DACC DRIVE IMPROVEMENTS

**Re: Construction Storm Water Inspection at DACC Drive Improvements / Delaware
County
Permit Number: 4GCO00050*AG**

Figure 1

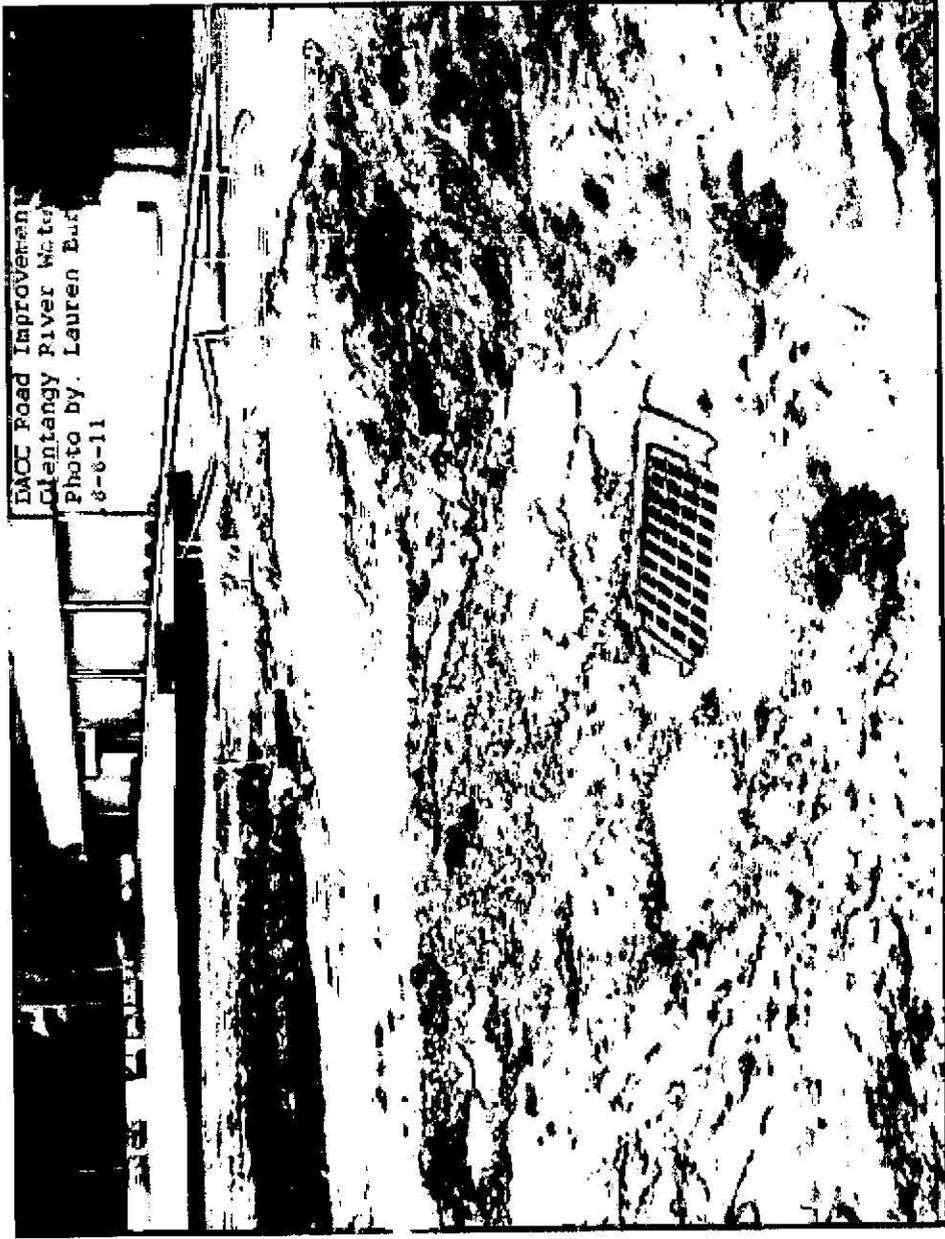
- Our staff noted several storm drains on site that lacked inlet protection from sediment (see Figure 1). Please take immediate corrective measures to minimize sediment laden discharges to waters of the state.
